Access Compliance Report Public Rights-of-Way (Curb Ramps)

Main Street: IRVINE_BLVD Cross Street: BROWNING_AVE Location: NE

ADA ID: RPRK220103133729 Ramp Type: Type 4 - Parallel Initial Pass/Fail: Fail Overall Compliance: No Severity Score: 2

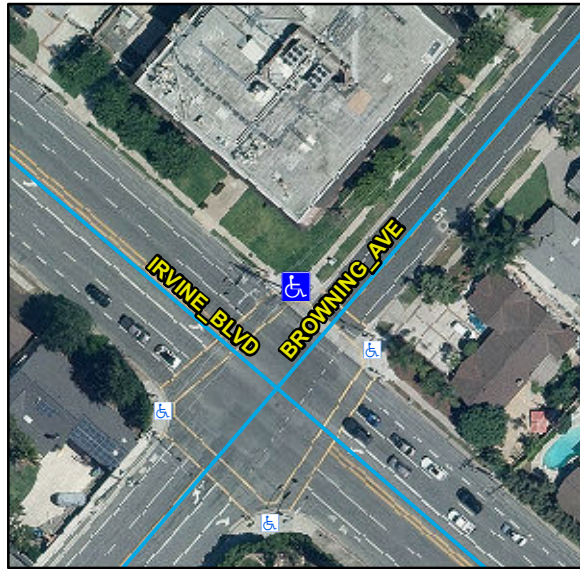
Compliance	Description	Data	Compliance	Description	Data
N/A	Ramp Length LT (in)	67	N/A	Ramp Length RT (in)	76
Yes	Ramp Width LT (in)	96	Yes	Ramp Width RT (in)	96
Yes	Ramp Run Slope LT (%)	4.4	Yes	Ramp Run Slope RT (%)	4.5
Yes	Ramp Cross Slope LT (%)	1.5	No	Ramp Cross Slope RT (%)	3.9
N/A	Landing Present	N/A	N/A	DWS Provided	N/A
N/A	Landing Length (in)	N/A	N/A	DWS Contrast	N/A
N/A	Landing Width (in)	N/A	N/A	DWS Length (in)	N/A
N/A	Landing Run Slope (%)	N/A	N/A	DWS Full Width	N/A
N/A	Landing Cross Slope (%)	N/A		DWS Offset Type	N/A
N/A	Landing Movement Obstructed?	N/A	N/A	DWS Offset Left (in)	N/A
	Landing Movement Type	N/A	N/A	DWS Offset Right (in)	N/A
N/A	Landing Shared	N/A			
N/A	Clear Space	Yes			
N/A	Clear Space To Crosswalk (in)	48			
N/A	Marked Crosswalk 1	Yes	N/A	Marked Crosswalk 2	Yes
	Crossing 1 Direction	SW		Crossing 2 Direction	SE
	Marked Crosswalk 1 Width (in)	144		Marked Crosswalk 2 Width (in)	144

Remove & Replace Curb Ramp With Two New Directional Ramps or Equivalent.

R304.5.3, STD 1115
